Service Bulletin No. 308

MODEL D / E / J Series Coaches	TYPE Field Change Program	SECTION/GROUP 13- Transmission	DATE Dec.16, 2008
SUBJECT ZF SOFTWARE UPDATE CAMPAIGN FOR CELL PHONE & RADIO INTERFERENCE			
CONDITIONS

Ref. ZF NHTSA Recall No.: 06E-100

Software Update campaign because of cell phone and radio interference (NHTSA no.06E100)

Figure 1. NO cellular phone decal.

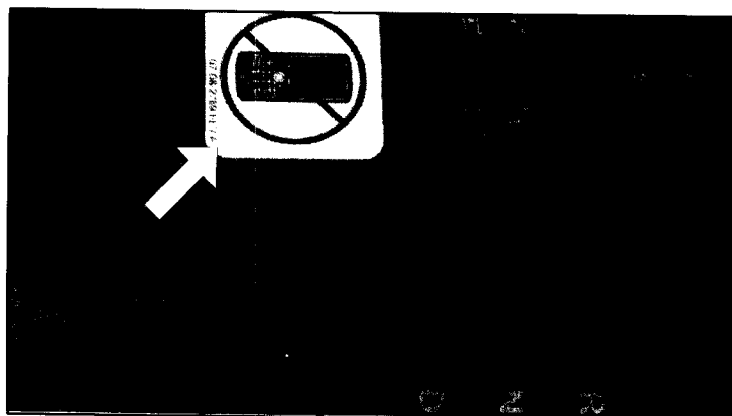
Qty.	New P/N	Description
1	07-08-2789	Decal, No Cell Phone

The only part required for this change is the 07-08-2789 Decal.
